**2008 LEAD (PB) NATIONAL AMBIENT AIR QUALITY STANDARD (NAAQS)
COMPLIANCE PLAN**

EXIDE TECHNOLOGIES-CANON HOLLOW FACILITY

**COMMENTS AND RESPONSES ON
PROPOSED REVISION TO
MISSOURI STATE IMPLEMENTATION PLAN –
2008 LEAD (Pb) NATIONAL AMBIENT AIR QUALITY STANDARD (NAAQS)
COMPLIANCE PLAN –
EXIDE TECHNOLOGIES-CANON HOLLOW FACILITY**

Chart 1

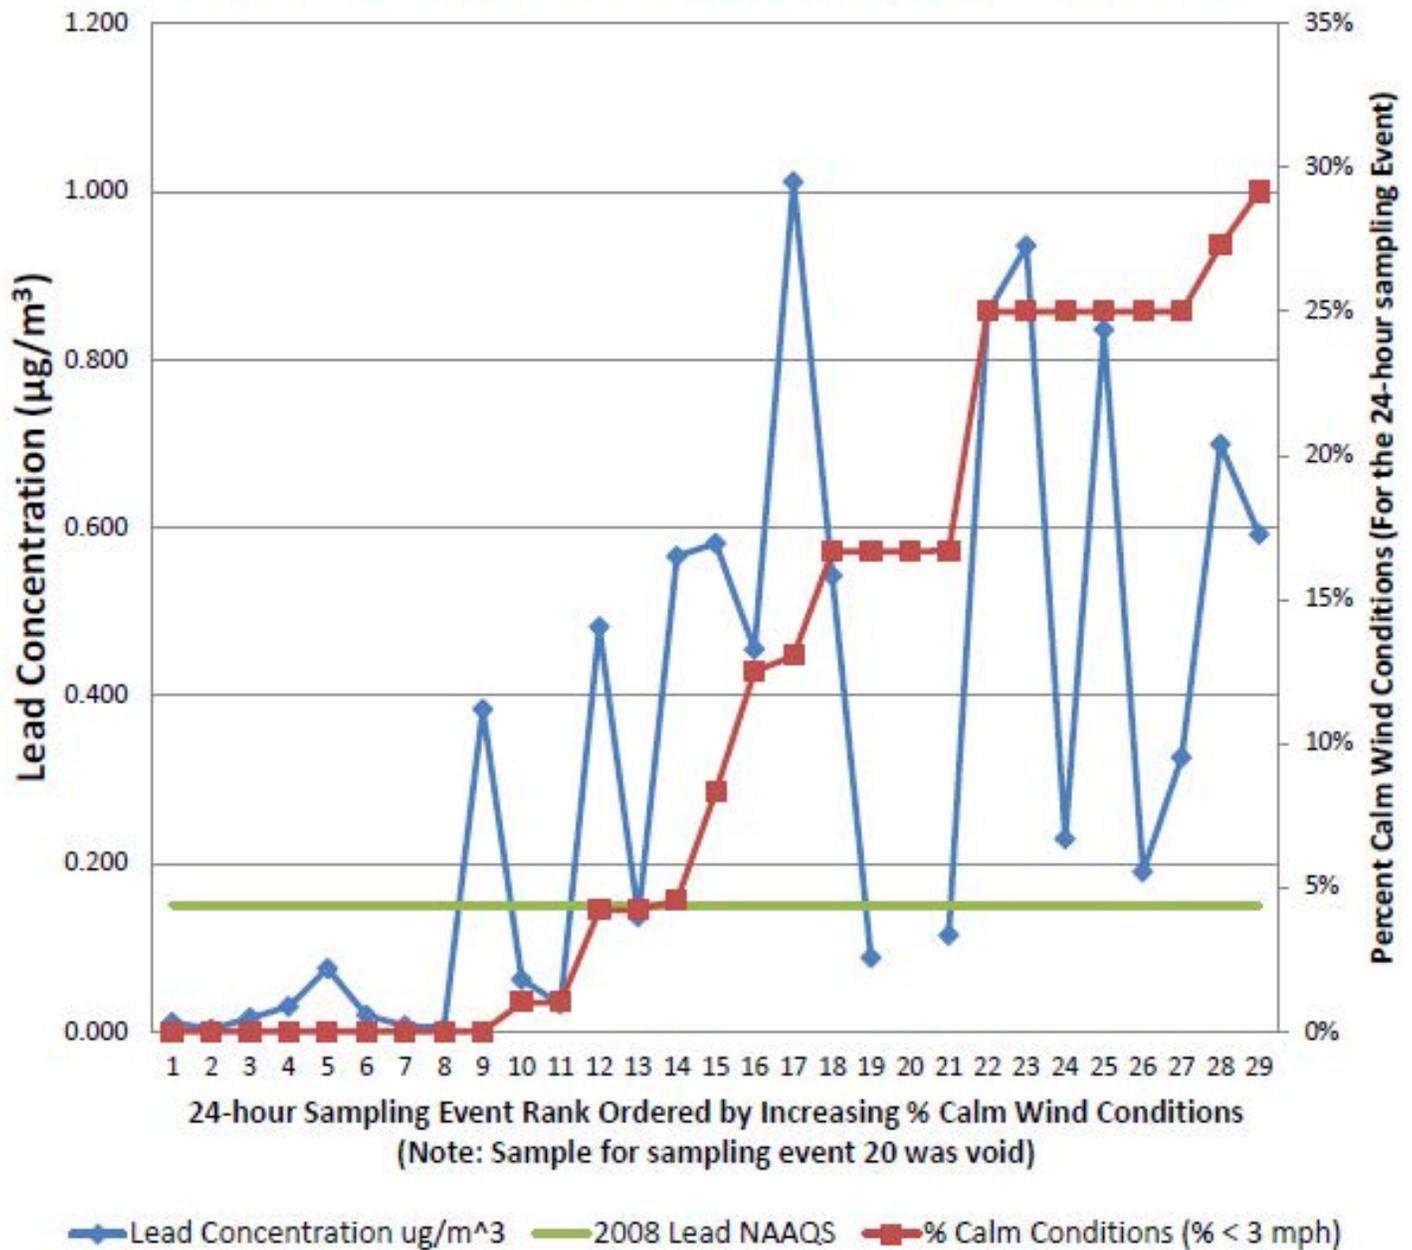
COMMENT #3: The commenter raises several concerns about the location of Forest City levee monitoring site. He notes reasons why the site is not ideal because of the direction of the prevailing wind, topography, and other siting criteria. Because of the location of the plan's maximum modeled result, he suggests a monitor location to the Northwest of the facility.

The Exide Levee ambient air monitoring site [EPA's Air Quality System (AQS) Site ID: 29-087-0008] is located approximately southwest of the smelter facility in an area that is subject to public access and considered in the ambient air. Analyses conducted by Air Program staff indicates that calm wind conditions tend to correlate with increasing airborne lead concentrations which suggests fugitive emissions are likely to be monitored at the Levee site despite the

predominant wind direction. See **Chart 1** below. This weight of evidence supports the continued use of the levee site as an indicator of how effective the new emission controls and management practices are at controlling fugitive airborne lead emissions and provide airborne lead data for demonstrating that the area meets the lead NAAQS.
